Agenda Item 3
1425 Telegraph Road
Continued Consideration of a New House on a Vacant Lot

1425 Telegraph Road

Continued consideration of plans for a new two-story single-family residence and the associated hardscape and landscape on a vacant lot.

Summary of Request

SITE PLAN

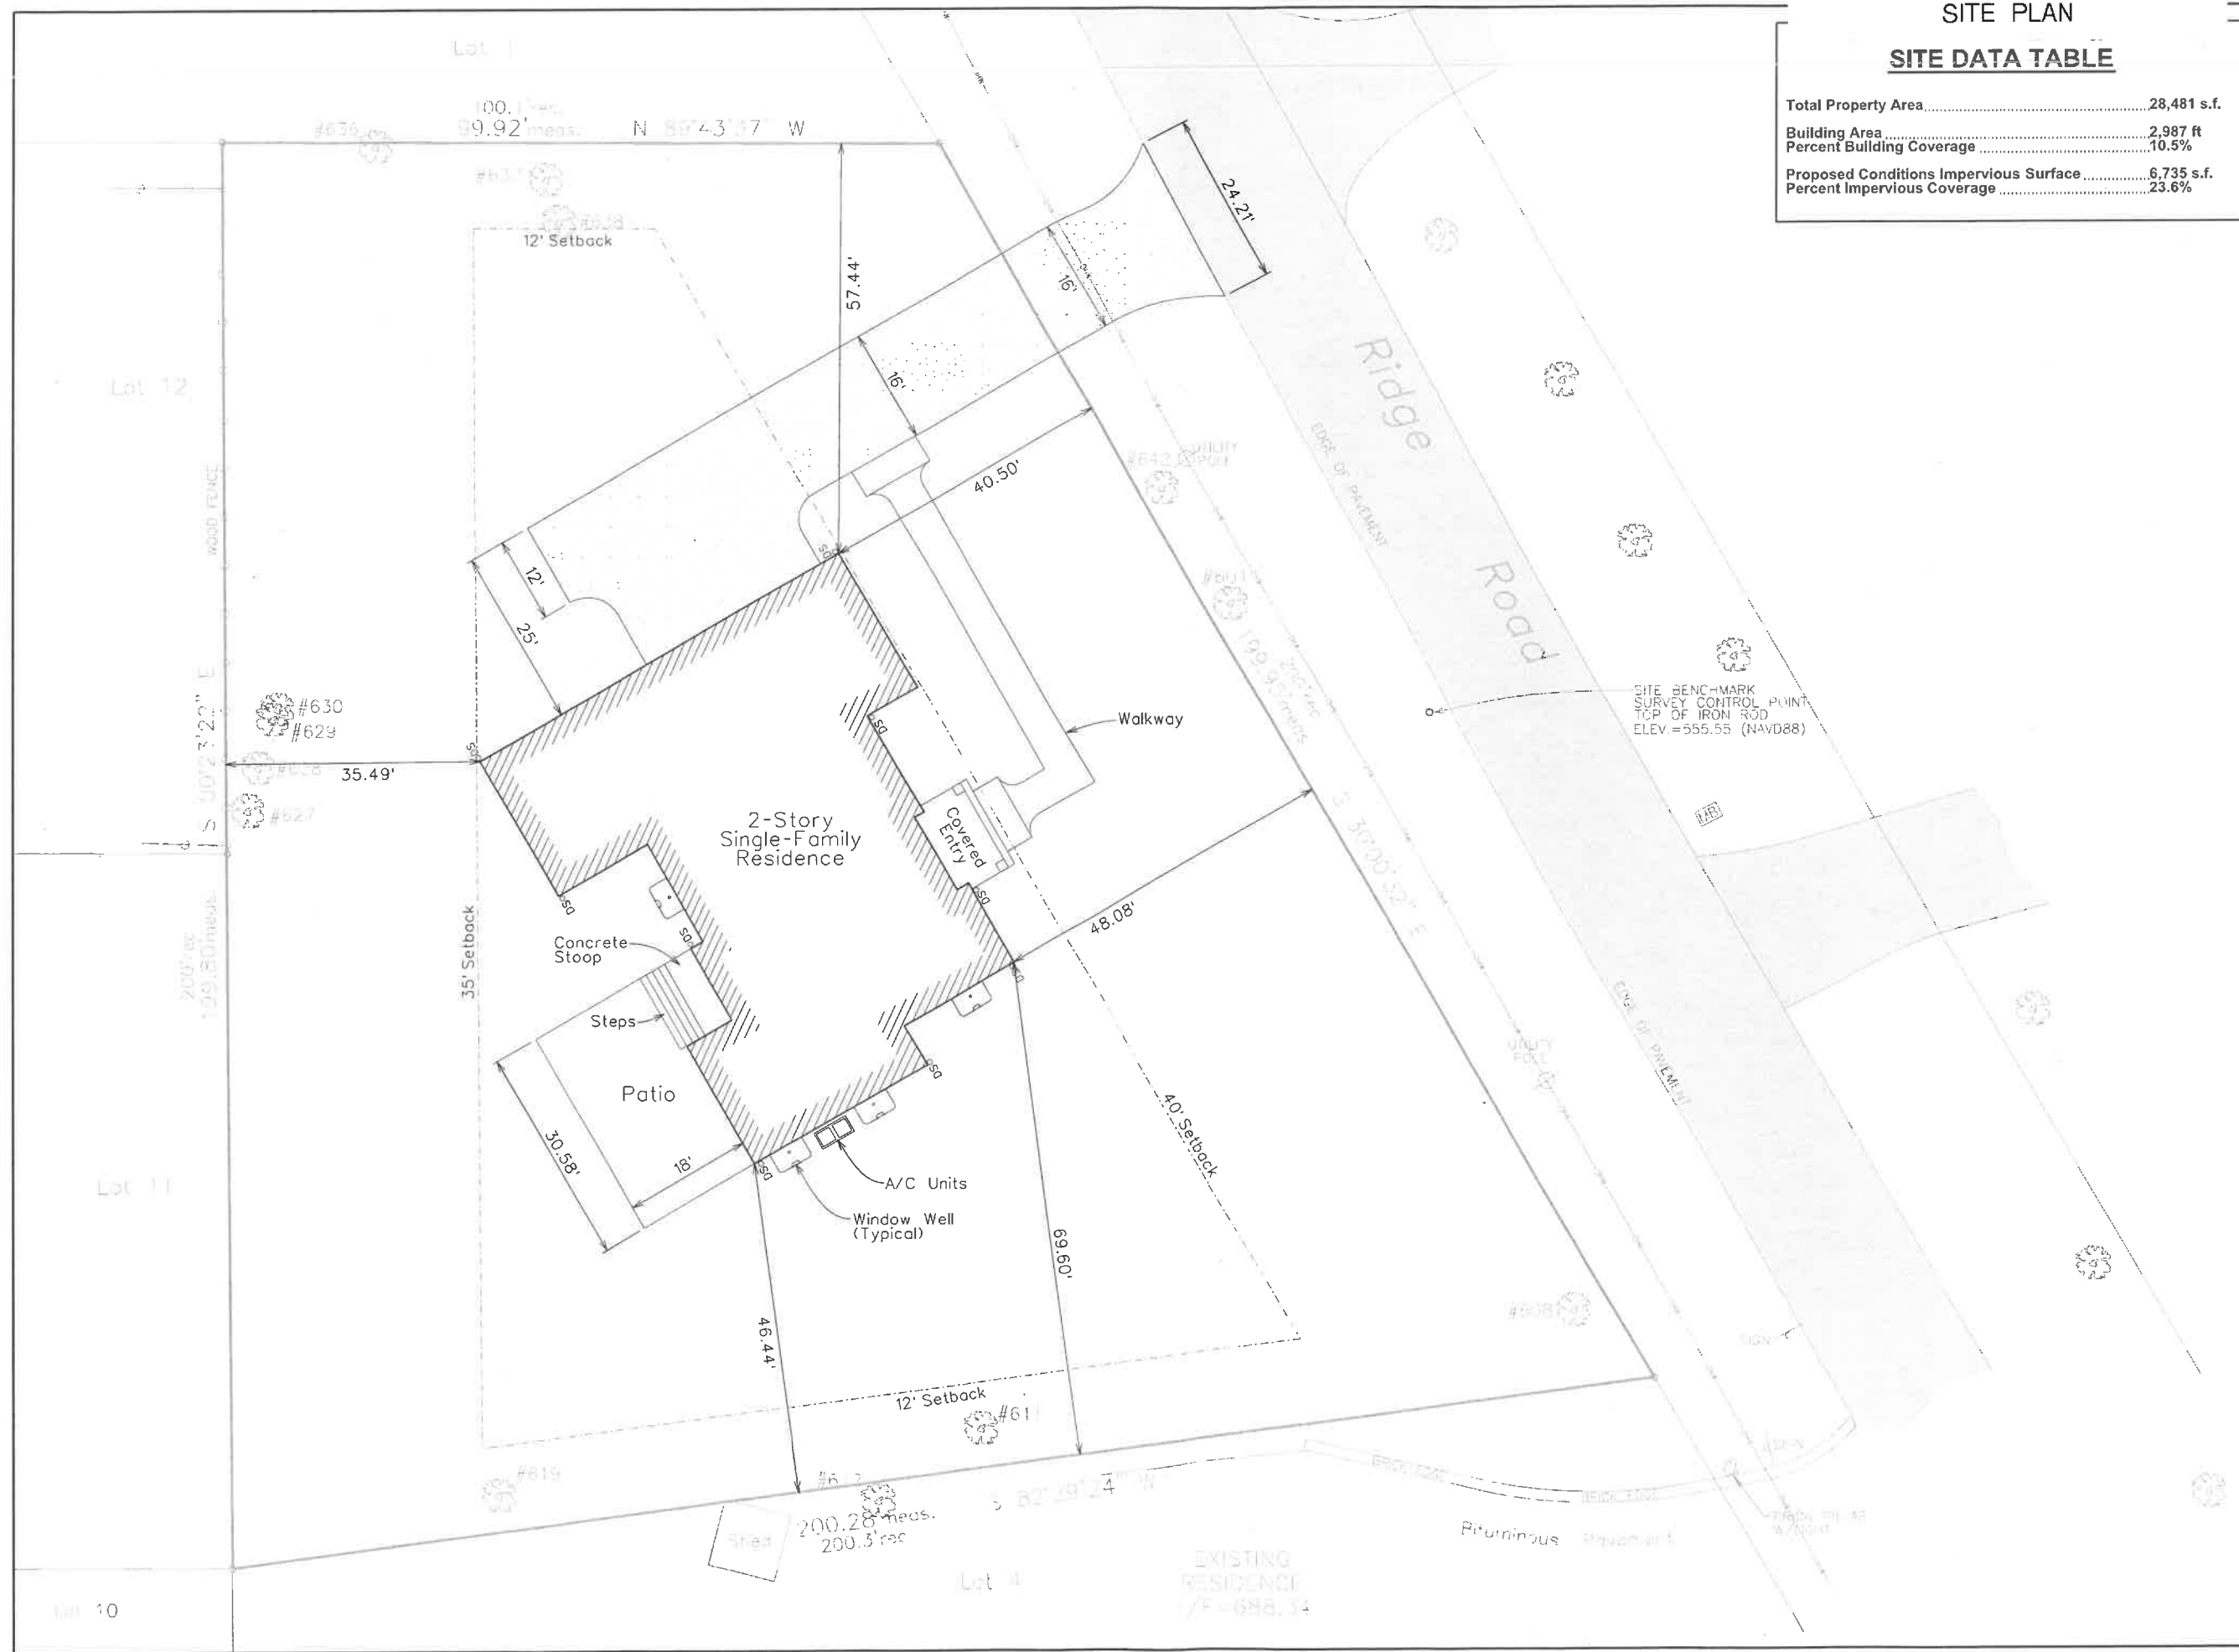
An engineer was consulted and moving the house toward the south/southwest was ruled out due to the topography of the site. To shift the house, significant grading would be required. To avoid this, the house is positioned as depicted in the site plan.

Please note, the u-shaped driveway is from a previous plan. The landscape plan needs to be updated. The prior driveway did not comply with the zoning regulations.

WEST AND NORTH ELEVATION

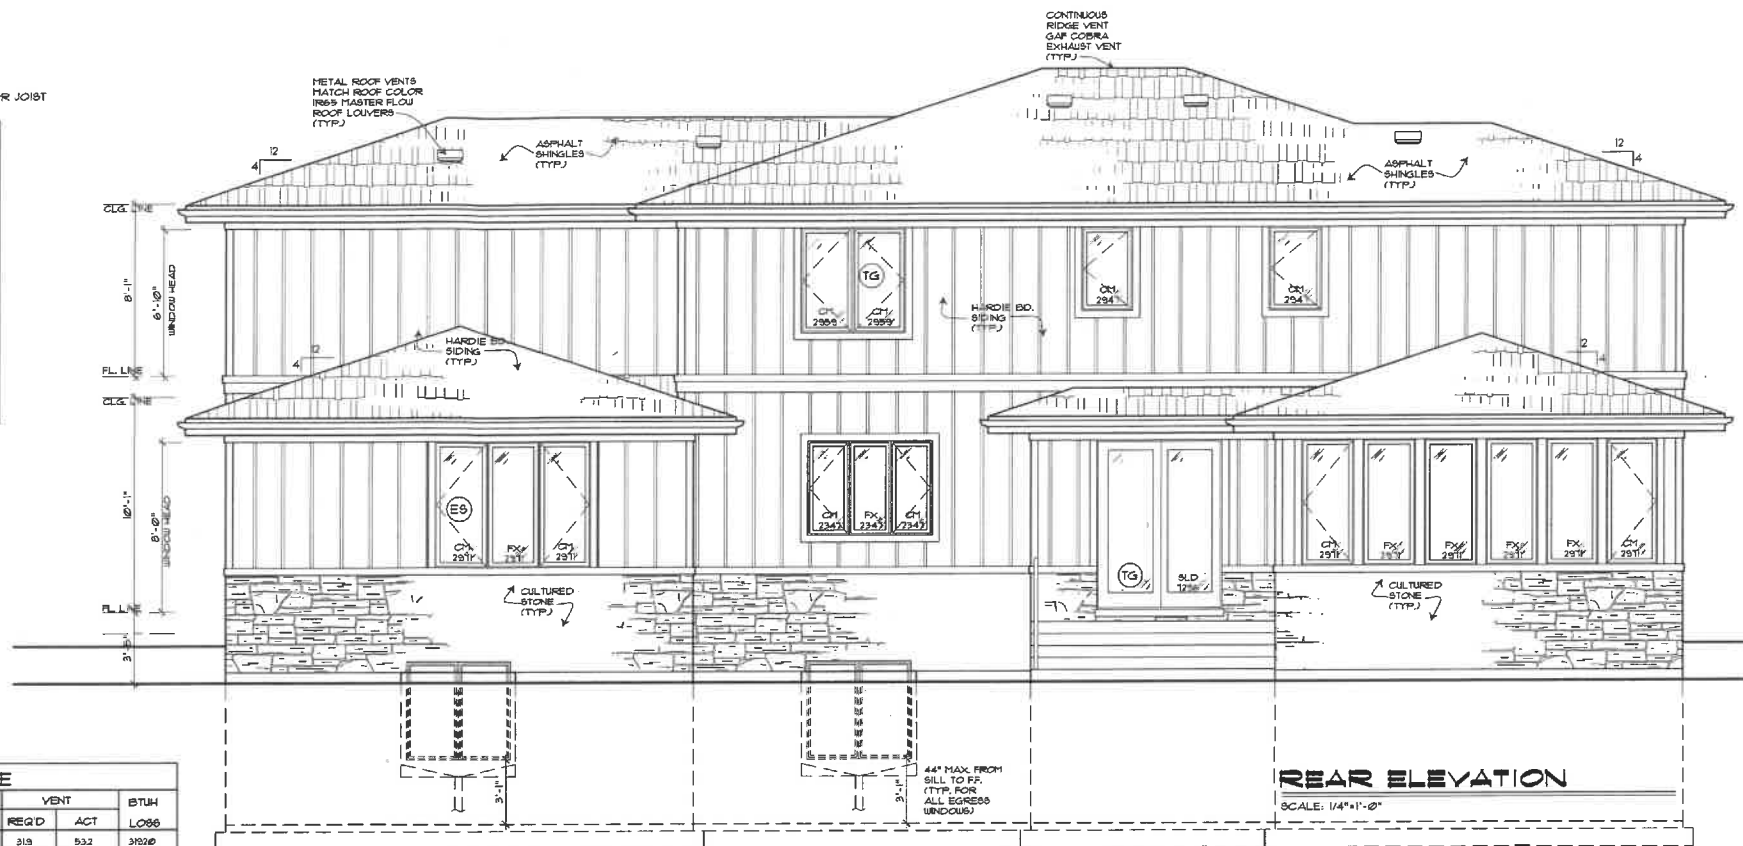
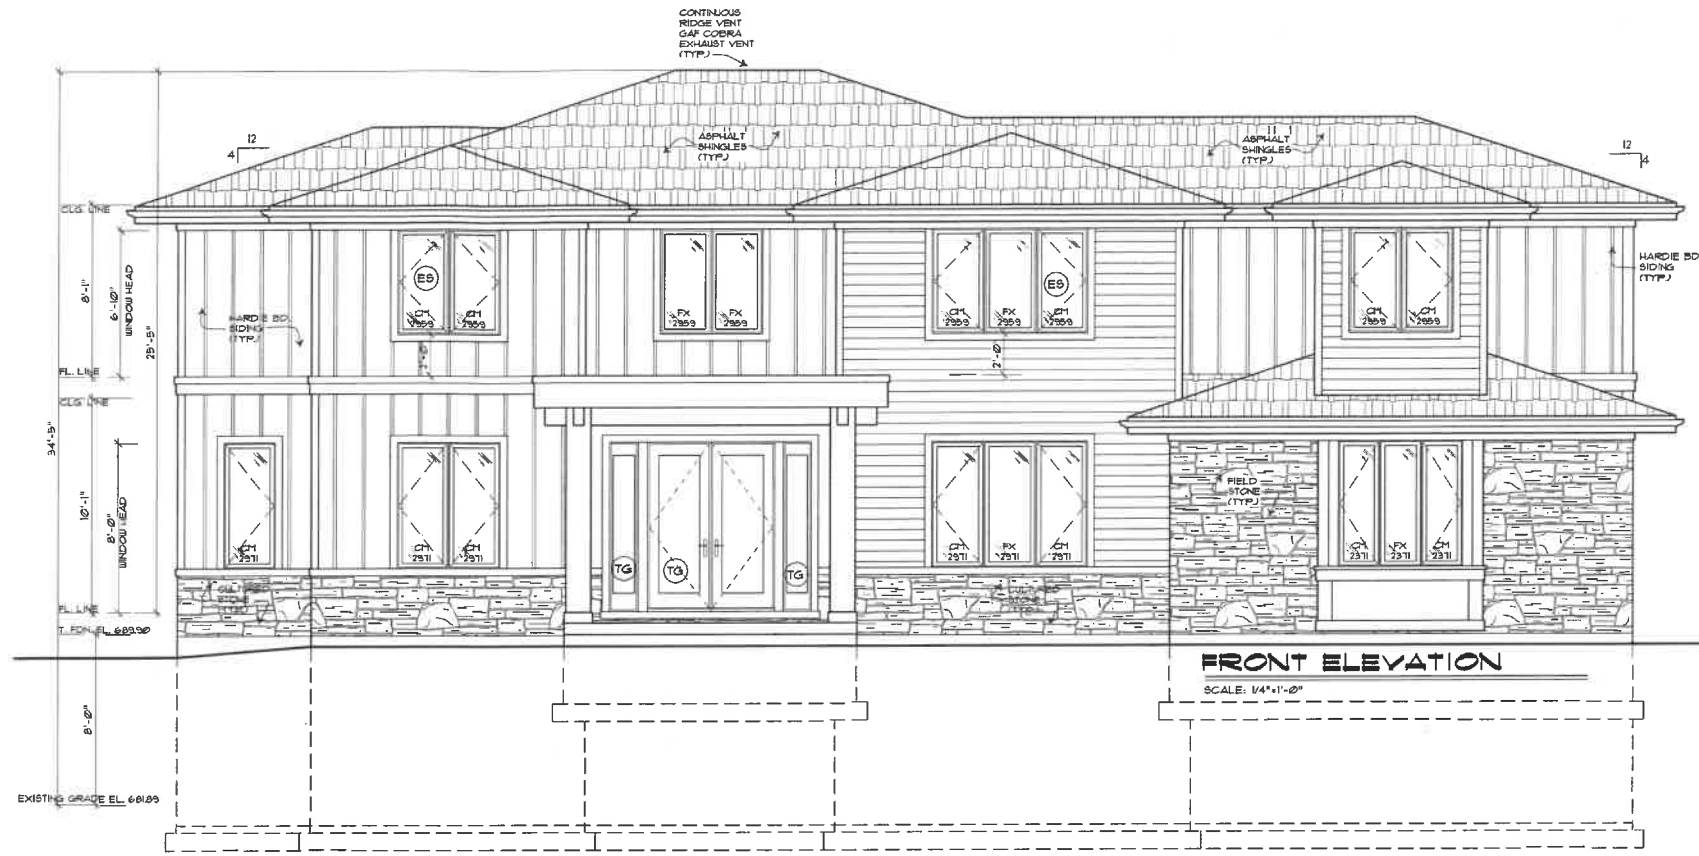
On the north elevation, continuing the stone band along the foundation between the two-car garage door and the single-car garage door should be considered to provide continuity.

CONCEPTUAL LANDSCAPE PLAN

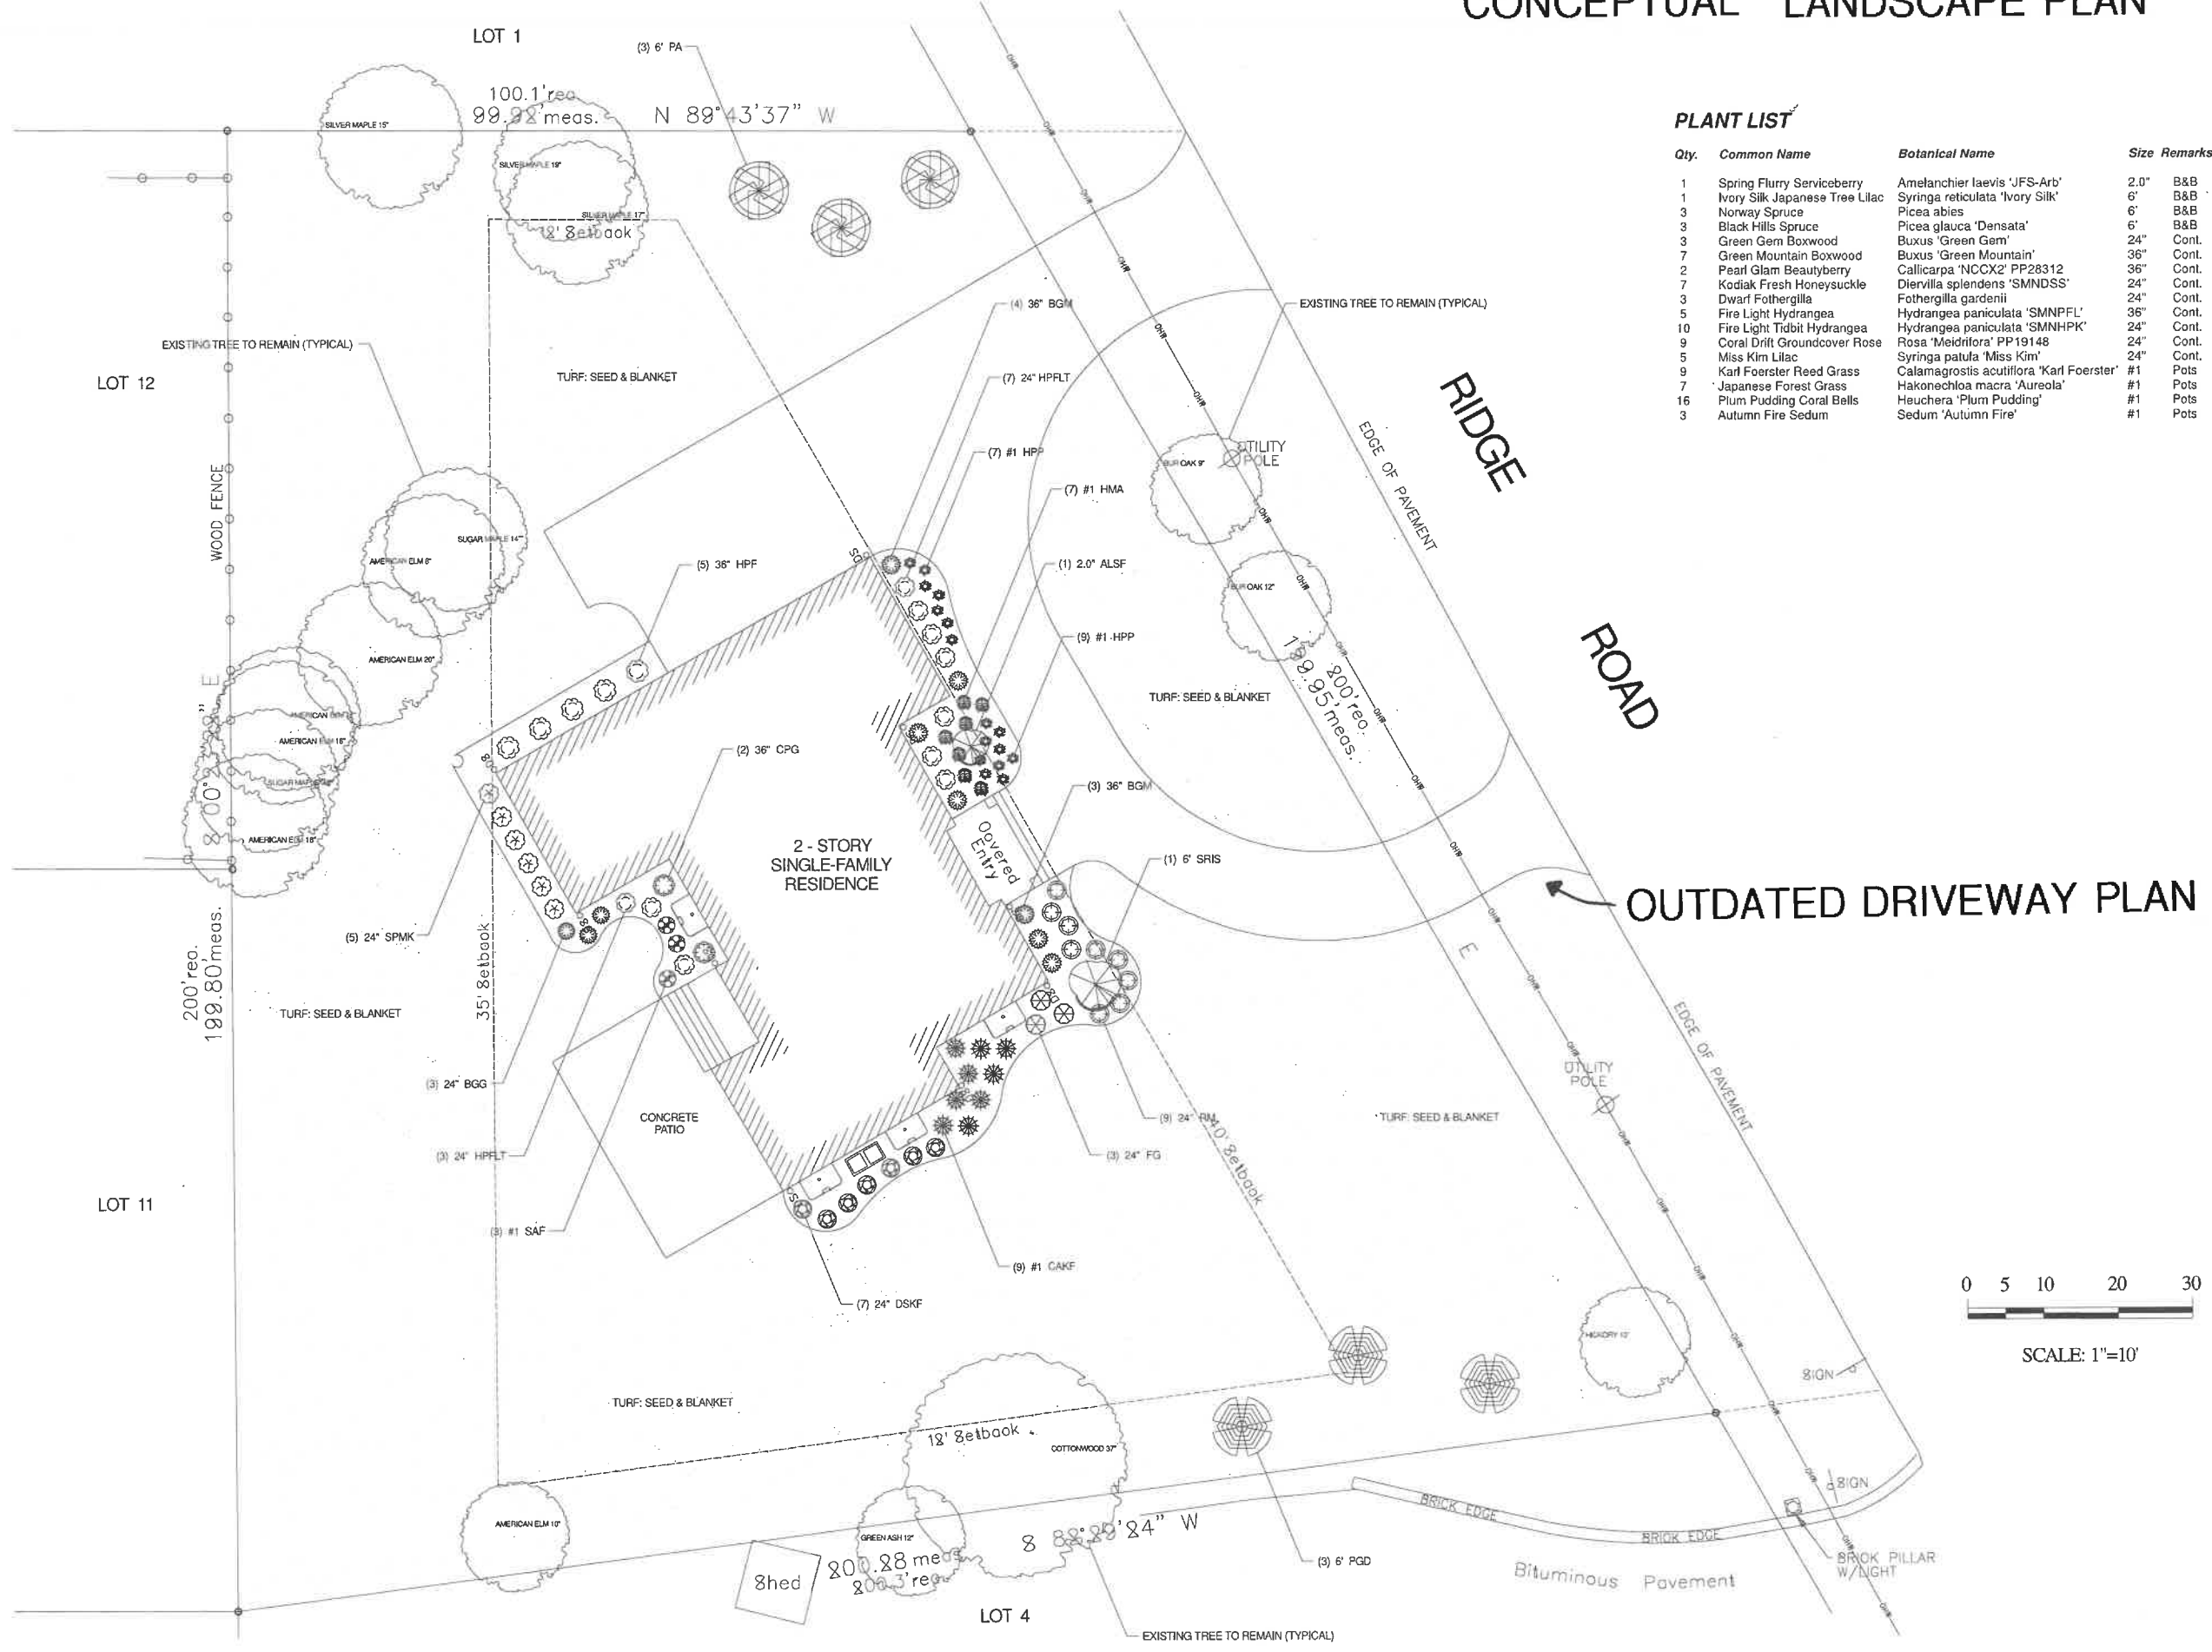
The conceptual landscape plan does not yet meet the minimum landscape criteria for new houses or demonstrate full replacement of the 24 inches. A landscape plan meeting the minimum criteria for new houses will be required along with the plans submitted for permit. The plan shall demonstrate 24 replacement inches or, if approved by the City's Certified Arborist, a fee in lieu of some of the inches will be accepted at the time the permit is issued.
